Section 2

Modifications and Updates to the Draft EIR

This section of this Final EIR contains modifications and updates to the Draft EIR based on minor corrections to formatting or grammar and on comments received from the public. No new or additional information has been added to the Draft EIR and no significant unmitigated impacts would occur. This section is organized into subsections that correspond to the section headings in the Draft EIR. Each subsection contains a list of the modifications (if any) that were made to the corresponding section. The Draft EIR section headings and corresponding subsection headings are as follows:

Figure 3.4-9
Locations of Odor Complaints near NEIS II and GBIS

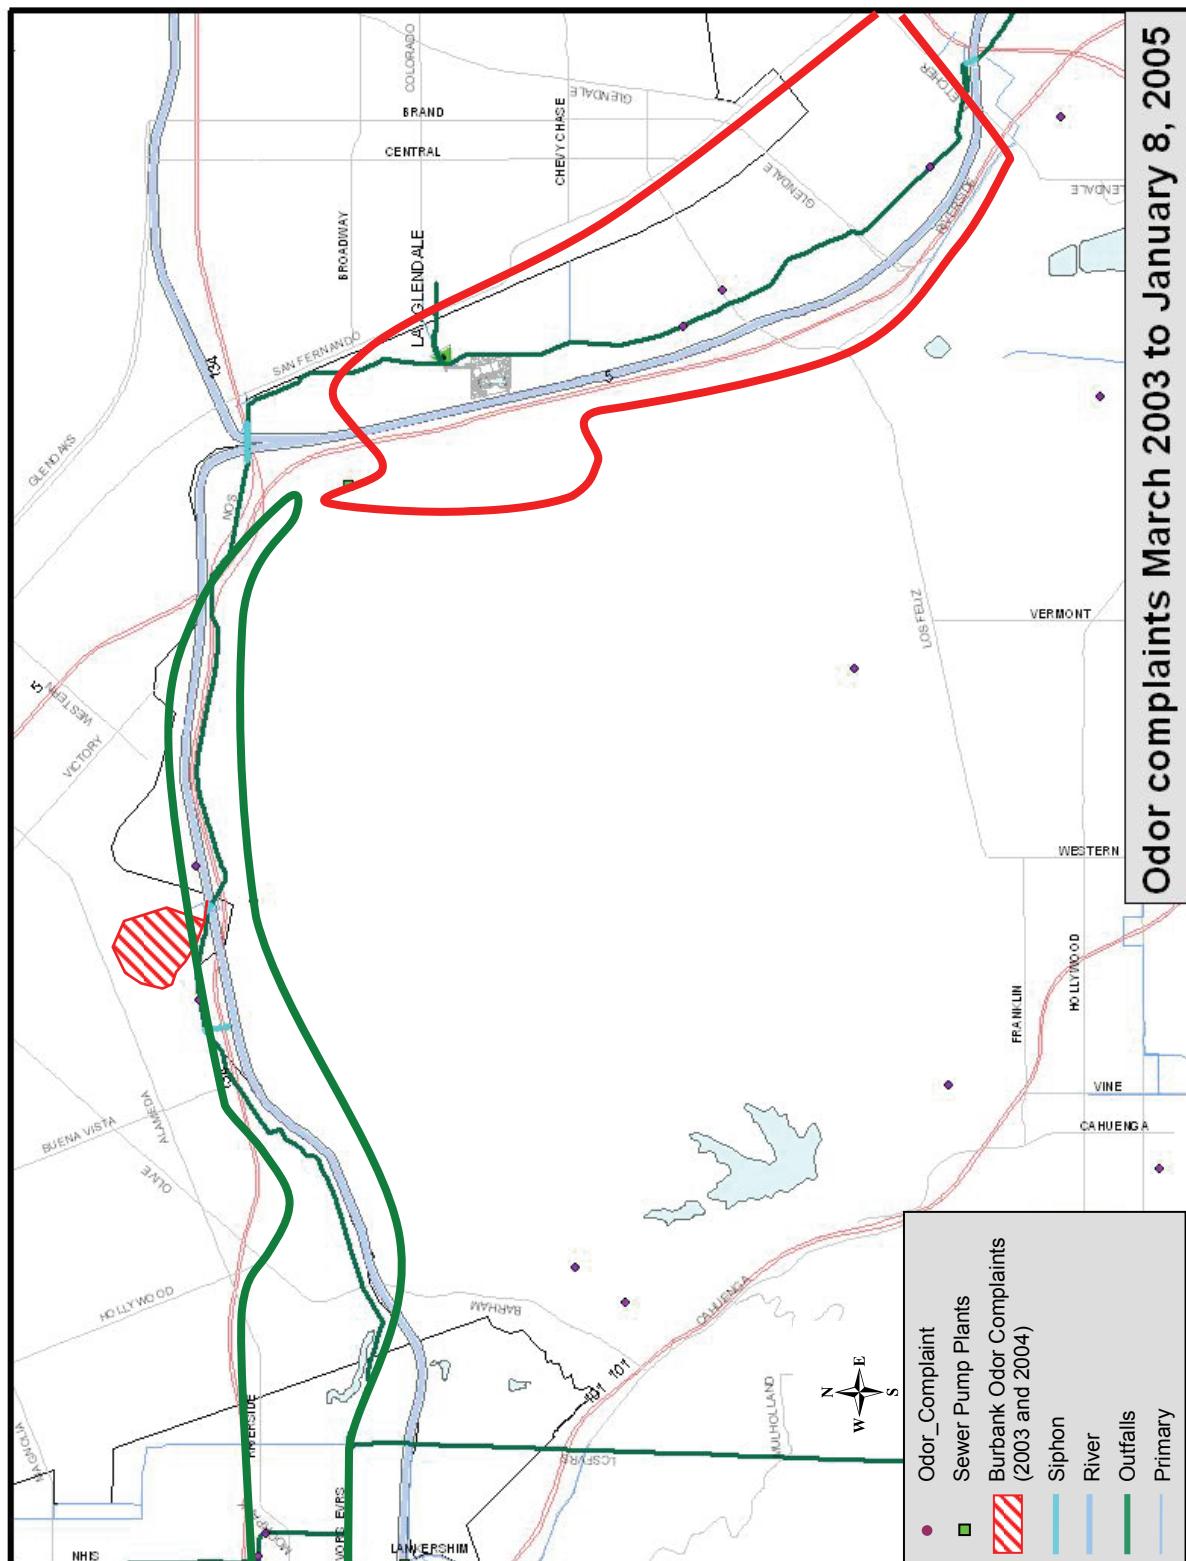
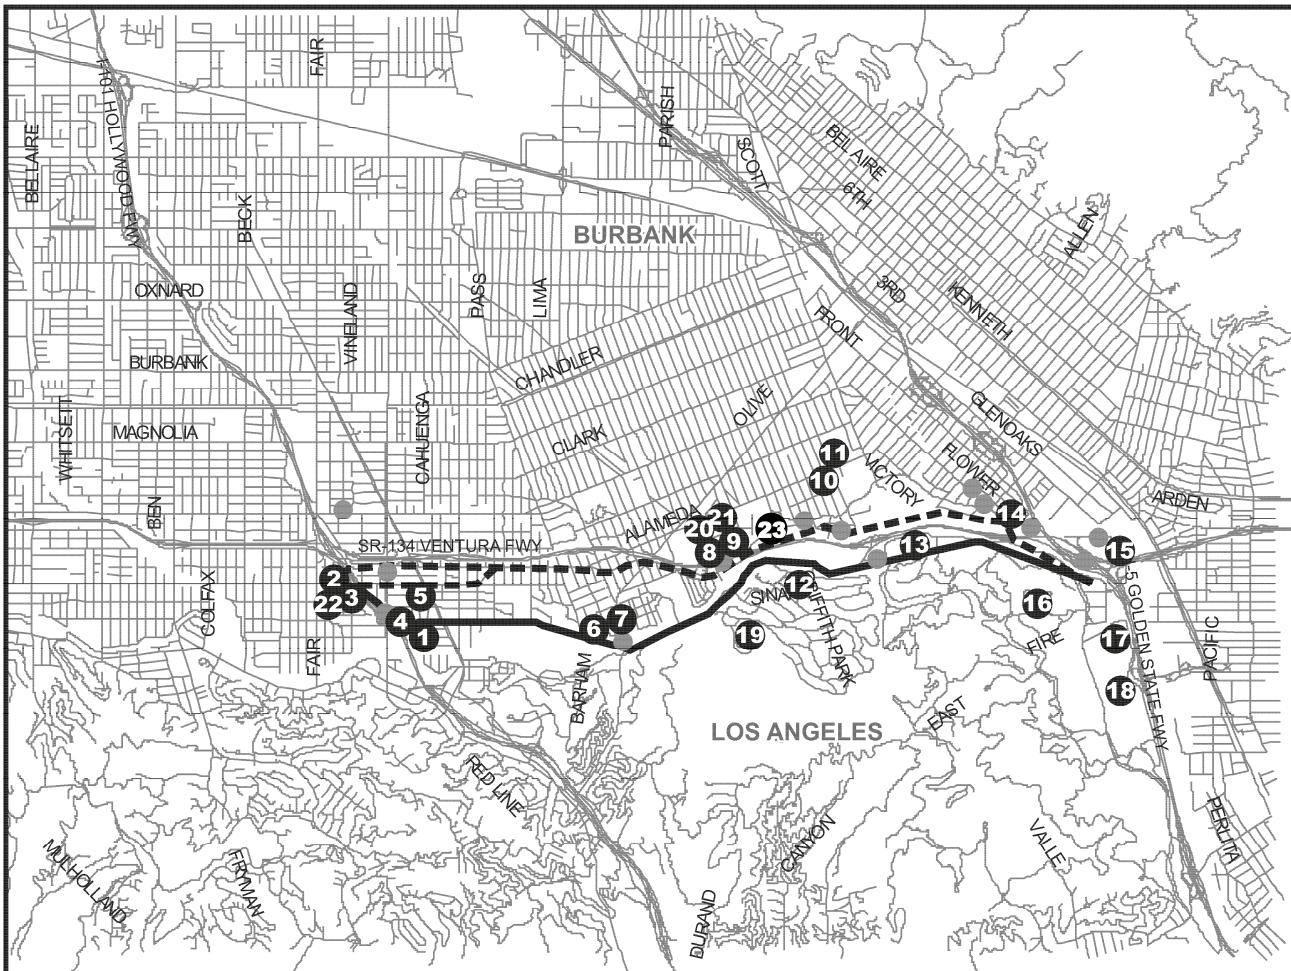
- Section 3.4.2.5, on page 3.4-43. Replace Figure 3.4-9 with the revised Figure 3.4-9 at the end of this section of the Final EIR.
- Section 3.4.2.5, on page 3.4-45. Add the following bullet under Johnny Carson Park:

“As shown in Figure 3.4-9, the GBIS vicinity had some odor complaints (i.e., in the City of Burbank) located near and to the north of the Valley Heart Shaft Site.”
- Section 3.4.2.5, on page 3.4-45. Replace the third (and last paragraph) under the *Odors* heading with the following:

“The proposed ATFs associated with each of the GBIS alignments could be constructed at sites near areas of previous odor complaints.”
- Section 3.4.2.5, on page 3.4-47. Replace Figure 3.4-10 with the revised Figure 3.4-10 at the end of this section of the Final EIR.
- Section 3.4.3.2, on page 3.4-115. Replace the last sentence of the page with the following:

Figure 3.12-2
Existing and Adjacent Land Uses at Tillman

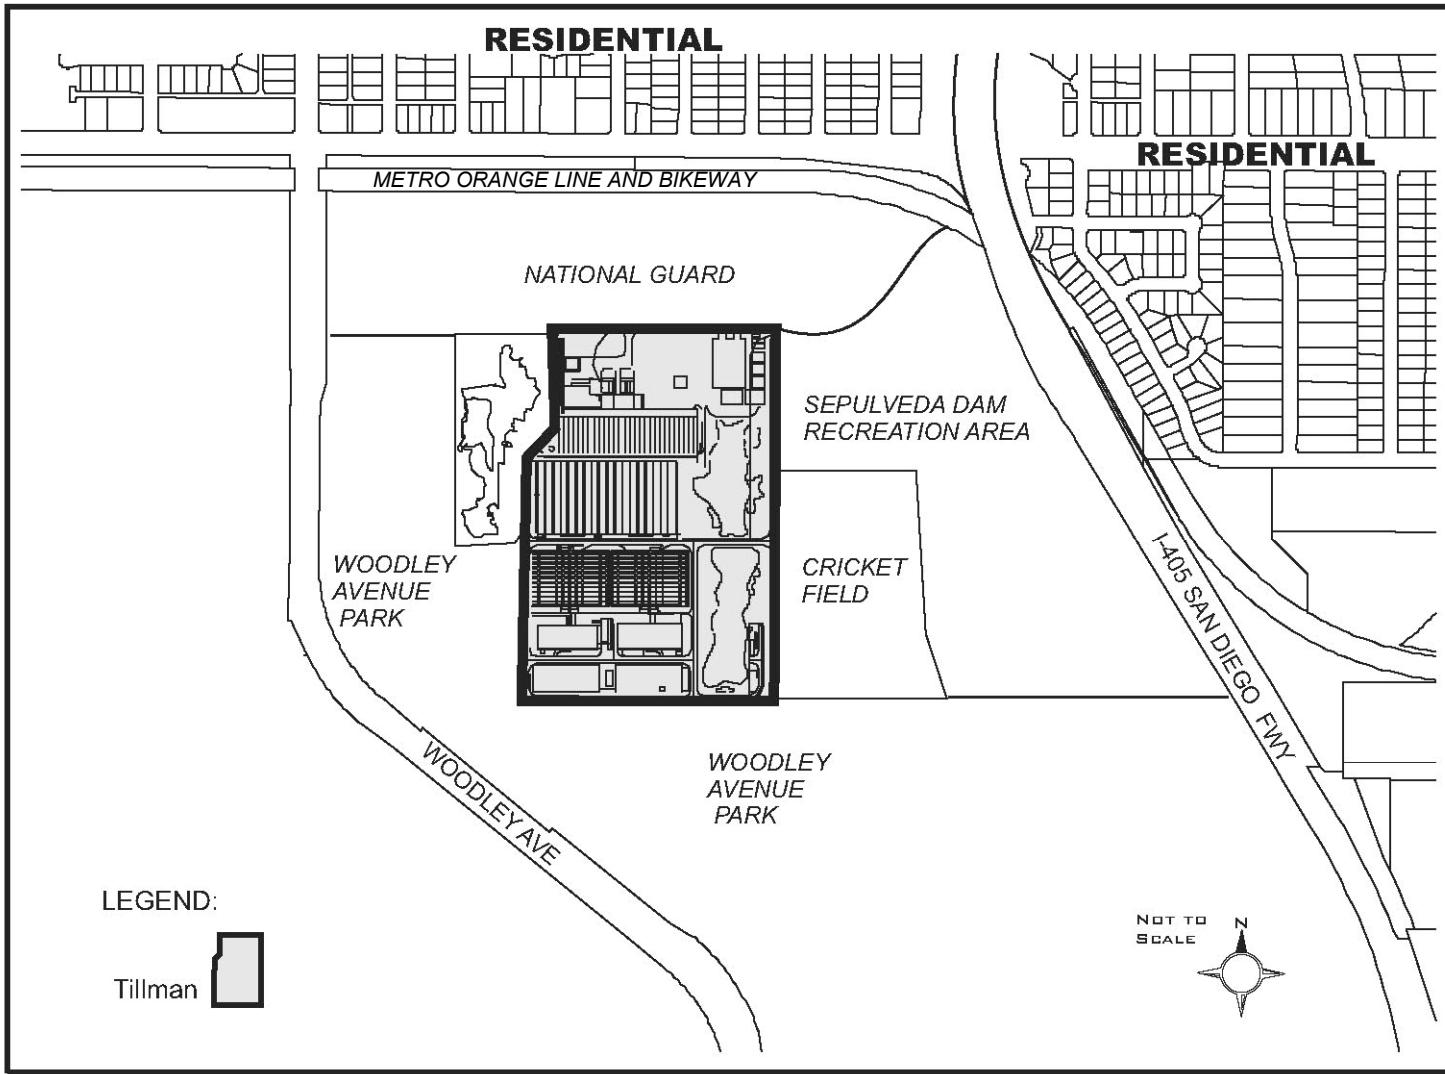
- Section 3.12.2.1, on page 3.12-7. Replace Figure 3.12-2 with the revised Figure 3.12-2 at the end of this section of the Final EIR.
- Section 3.12.2.2, on page 3.12-14. Replace the third sentence of the second paragraph with the following:

Figure 3.16-5
Recreational Resources Near GBIS

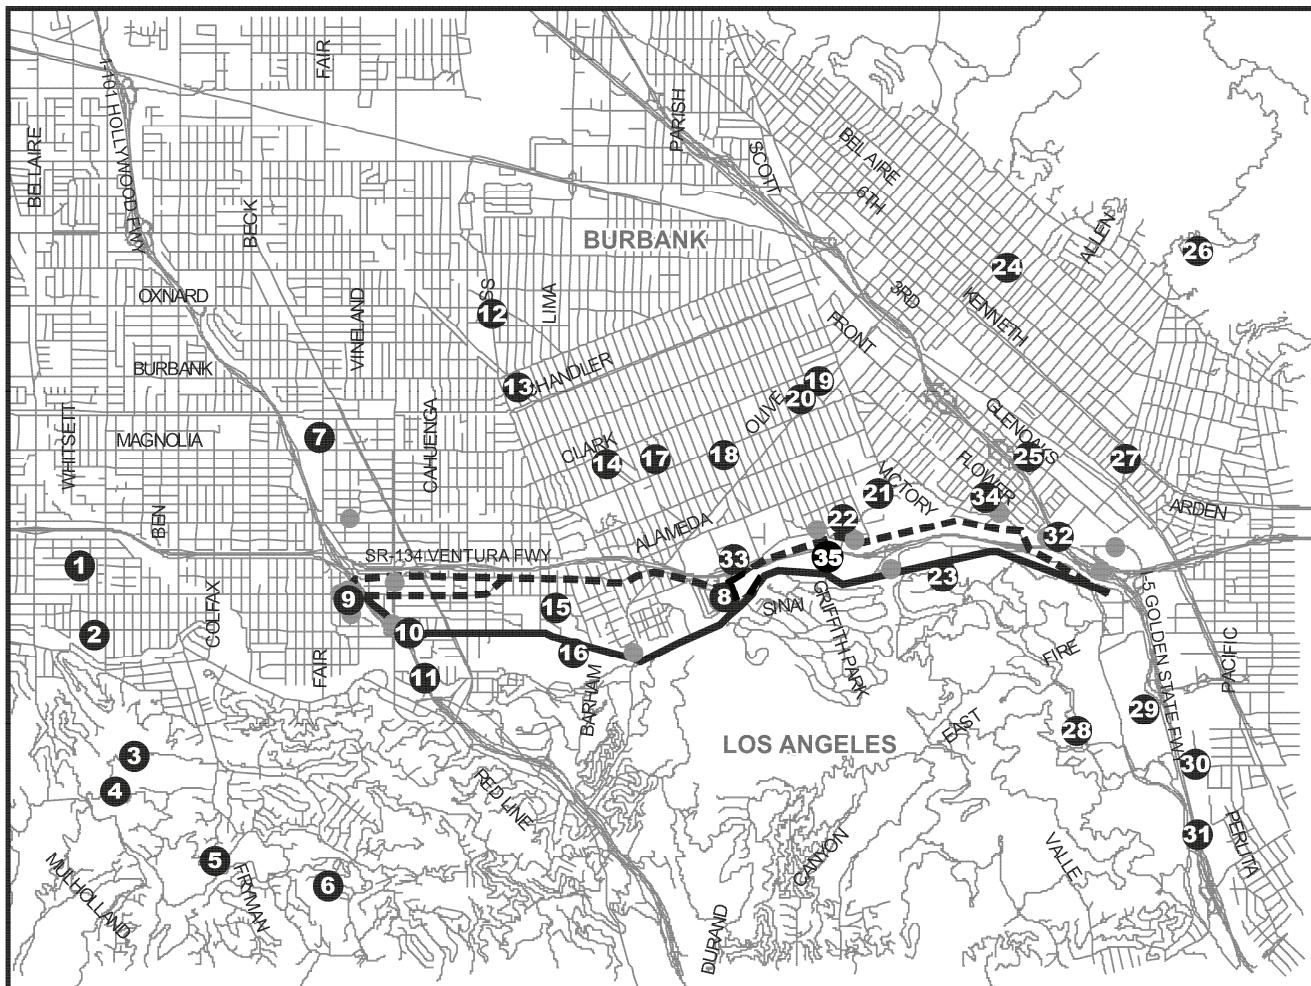
- Section 3.16.1.3, on page 3.16-23. Replace Figure 3.16-5 with the revised Figure 3.16-5 at the end of this section of the Final EIR.
- Section 3.16.2.2, on page 3.16-30. Replace the last complete sentence with the following:

Figure 3.17-2
Potential Alignment of GBIS

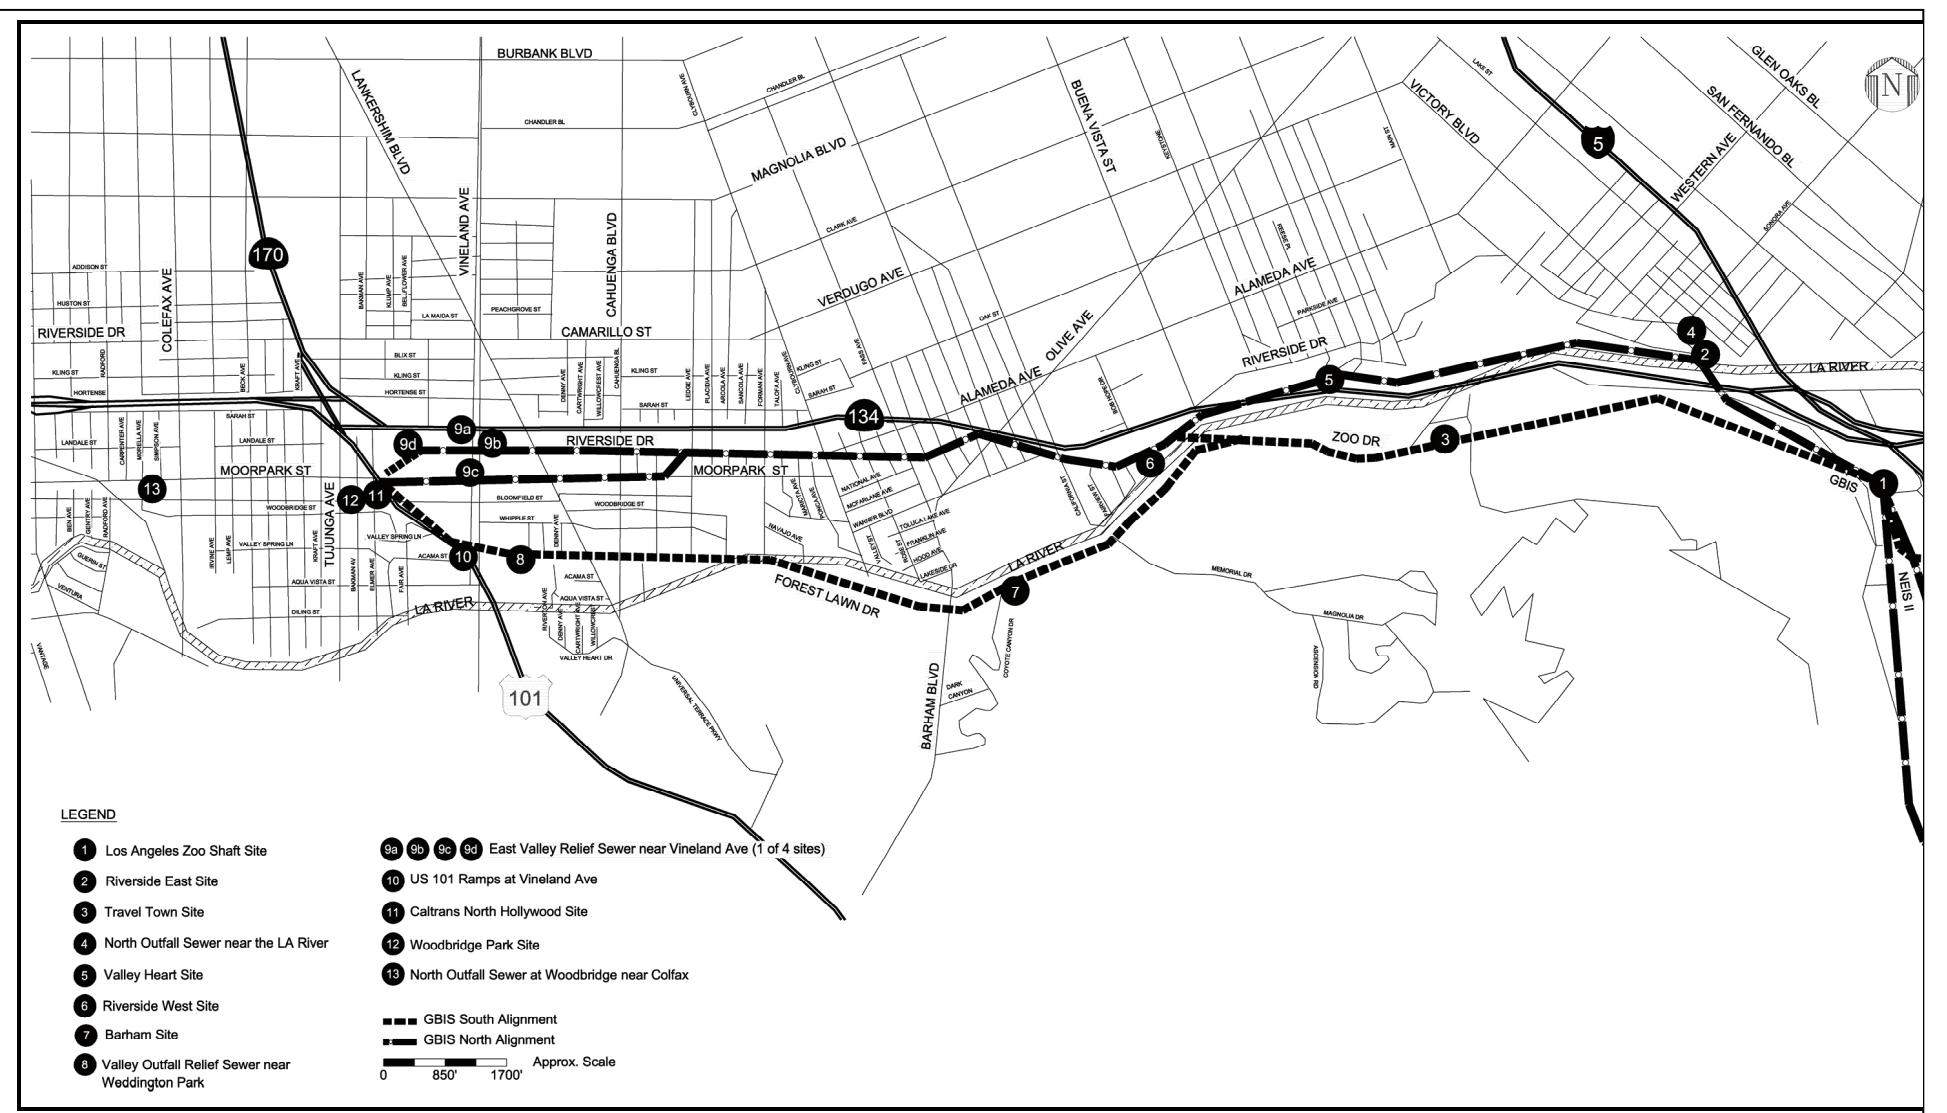
Section 3.17.2.2, on page 3.17-7. Replace Figure 3.17-2 with the revised Figure 3.17-2 at the end of this section of the Final EIR.
